**Regional Resource Recovery Centre, Pt Lot 78
and Pt Lot 85 Bannister Road, Canning Vale**

Southern Metropolitan Regional Council

**Report and recommendations
of the Environmental Protection Authority**

**Environmental Protection Authority
Perth, Western Australia
Bulletin 938
June 1999**

Figure 3. Plant layout.

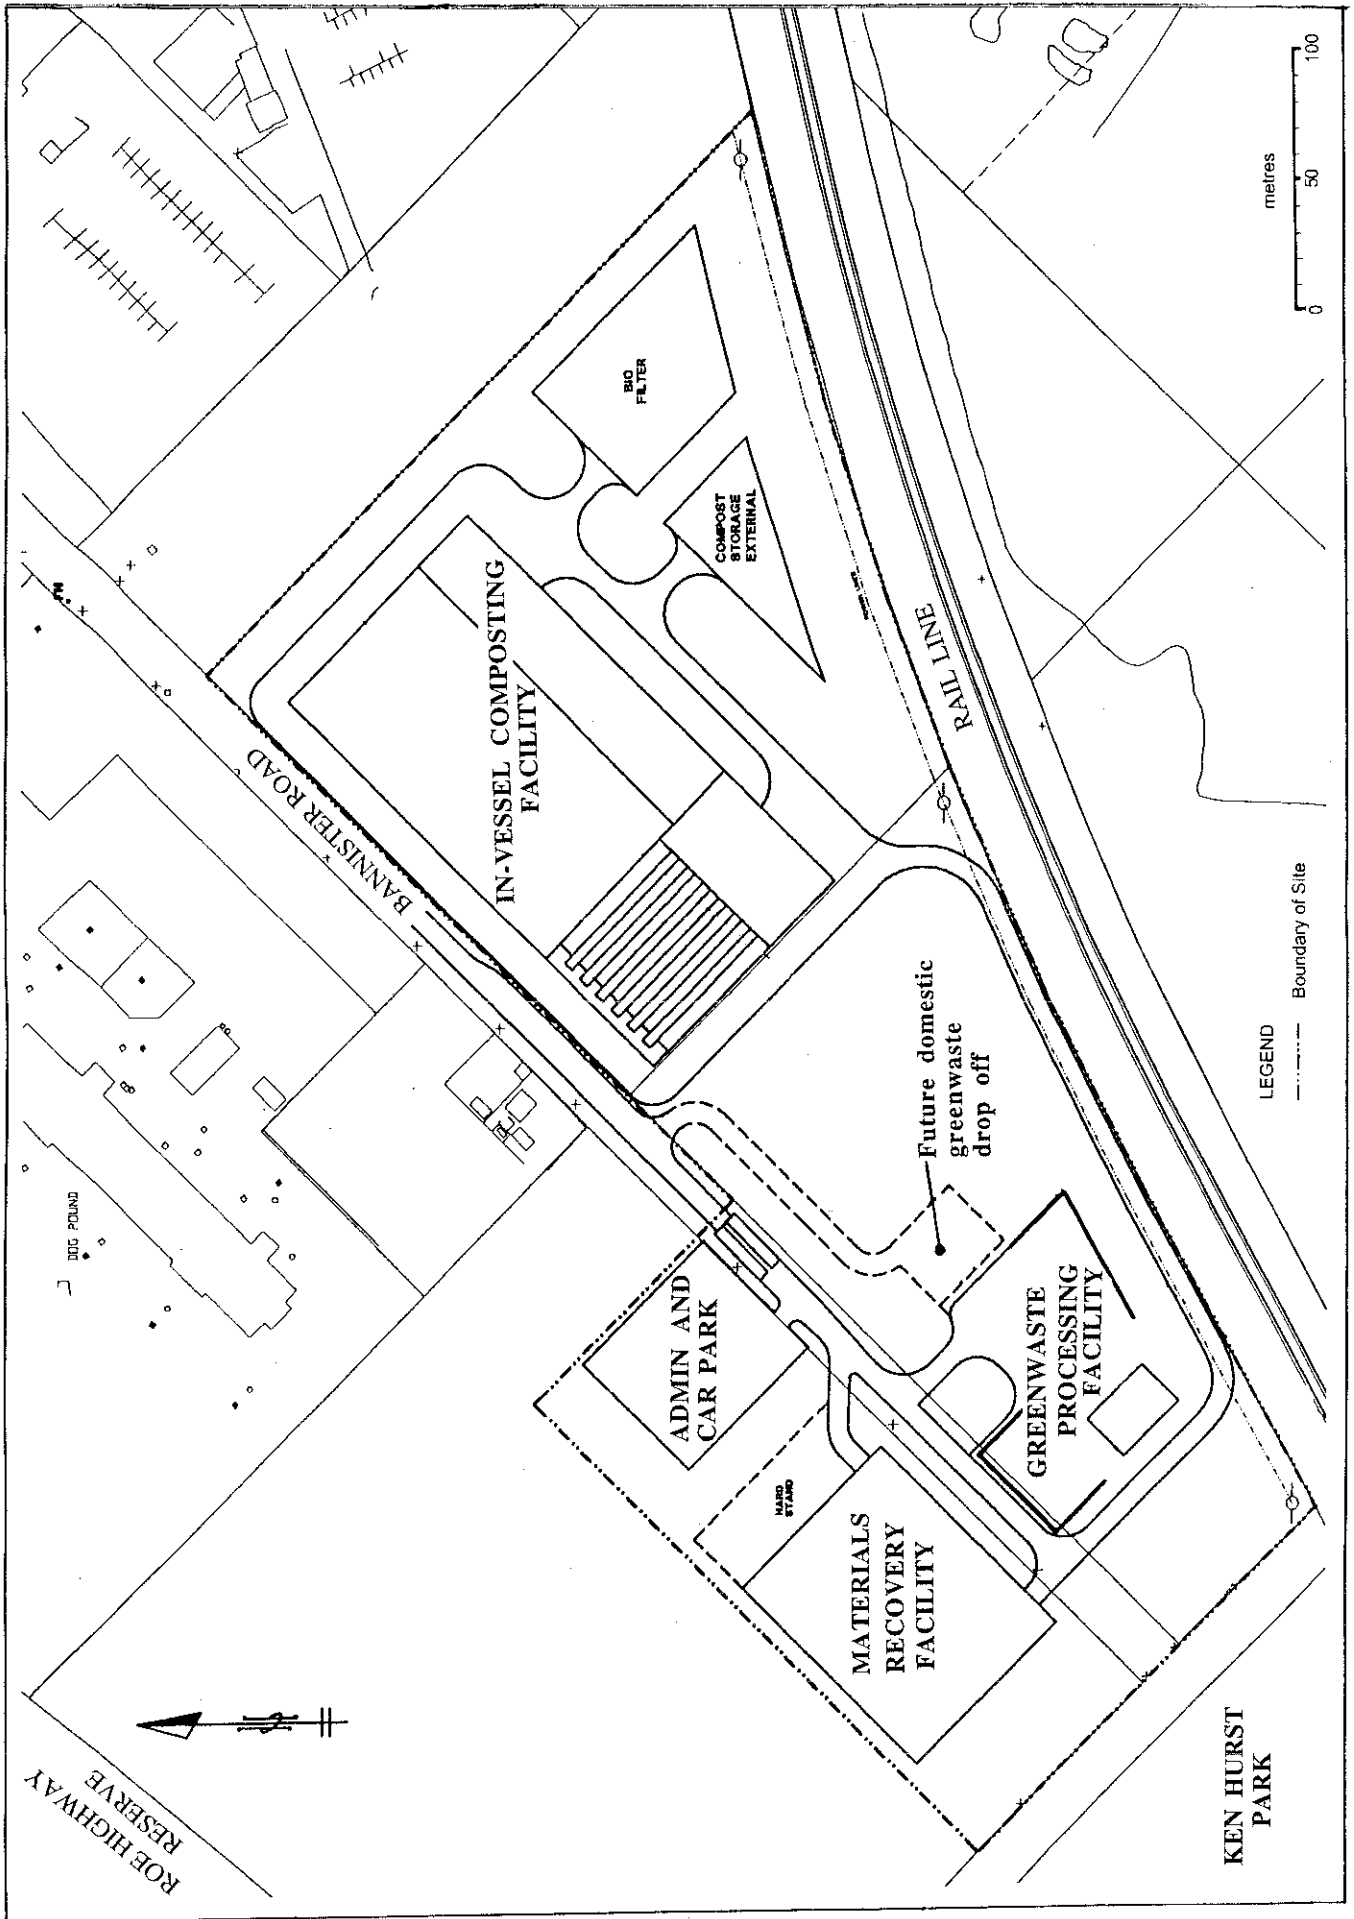
Since release of the CER, the proposed site layout has been revised by the proponent to the layout shown in figure 3. Environmental advantages of the revised layout include:

- the value of retained vegetation has been increased by moving the buildings away from the Ken Hurst Park boundary;
- an internal road has been relocated along an area already cleared for a powerline easement;
- the MRF building now provides additional acoustic screening for the greenwaste grinder plant which is a significant noise source;
- the in-vessel composting building provides additional acoustic screening for mobile equipment operating at the northern end of the site; and
- the continuous odour sources (biofilter and mature compost storage area) have been sited further away from the nearest residences.

The proponent has provided a revised site layout which increases the value of retained vegetation by moving the buildings away from the Ken Hurst Park boundary. An internal road has also been relocated along an area that is already cleared for a powerline easement. The proponent has also made a commitment to review the site layout for reasonable opportunities to preserve additional vegetation.

Figure 4. Odour contour.

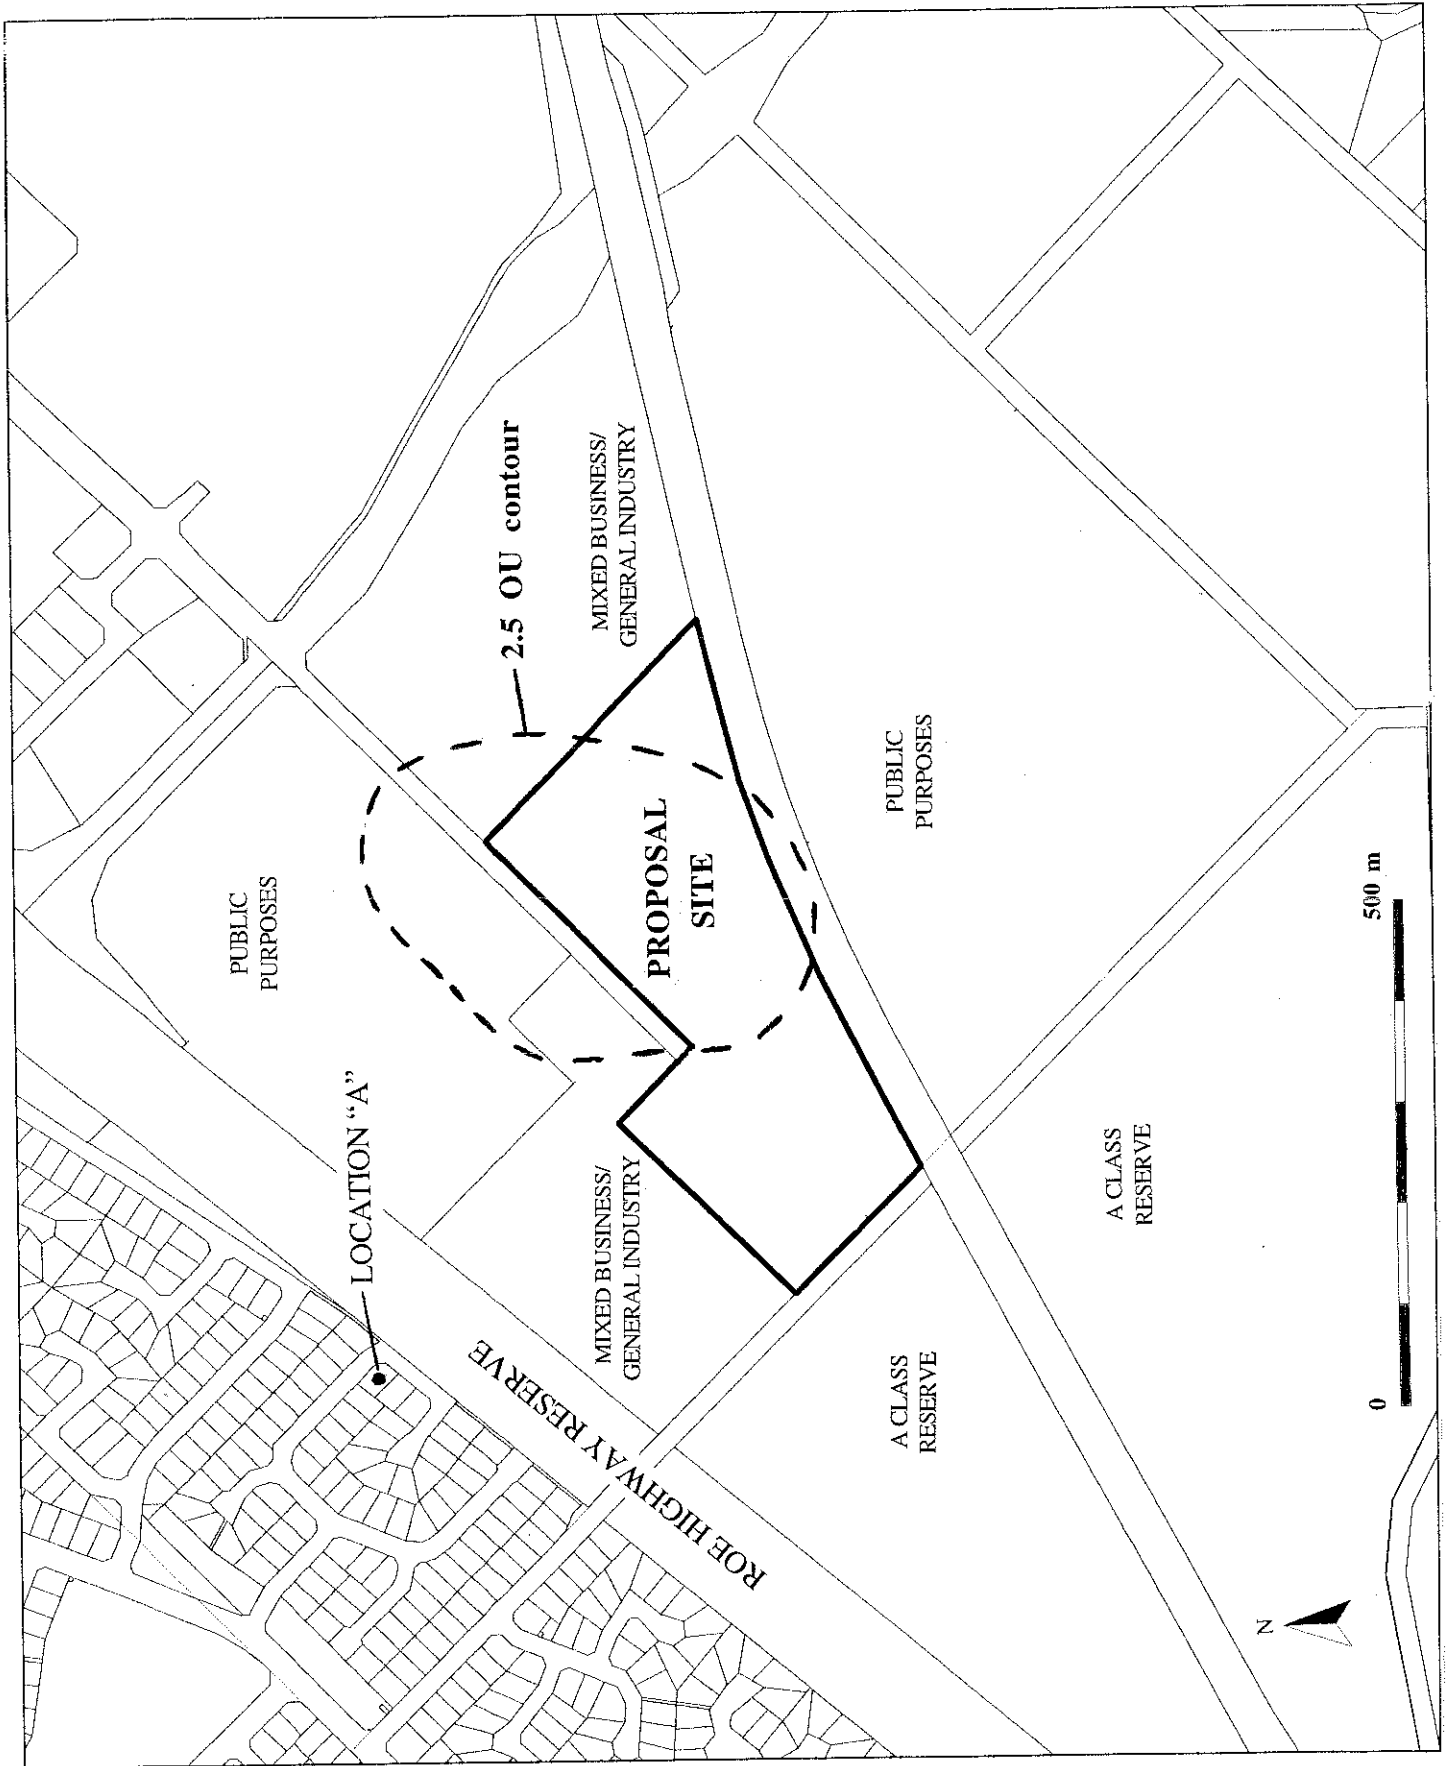
The proponent has provided odour modelling which predicts the 2.5 OU contour falls approximately 300 metres from the nearest residences (Figure 4). The odour modelling was based on sampling conducted at a similar plant in the USA, and on samples from a composting operation in Perth. The proponent has provided a revised site layout which moves the continuous odour sources (biofilter and the mature compost storage area) away from the nearest residences. This would shift the 2.5 OU contour further away from residences and the proponent has made a commitment to provide additional odour modelling during the Works Approval process once the detailed design is completed to confirm compliance.

The DEP considered odour to be manageable, but sought clarification and further information relating to odour emissions and odour management.

The EPA believes that in order to meet community expectations for a facility of this type and location that extra vigilance is required to ensure that odour does not cause a nuisance. The EPA notes the plant design incorporates multiple digesters, extraction fans and biofilter cells along with a standby power supply, which allows the odour control system to continue to function in the event that any one item fails or is down for maintenance. An automated alarm and out of hours notification system is included to notify a responsible person in the event of upset conditions. The EPA considers that these features provide the necessary assurance that the odour control system can function adequately at all times.

The EPA notes the proponent's commitment to provide a further assessment of odour emissions from the final plant configuration to demonstrate compliance with the odour criterion and to prepare an Odour Monitoring Plan which would include an initial dynamic olfactometry assessment, regular qualitative assessments of odour from the facility along with a odour complaint registration and investigation system.
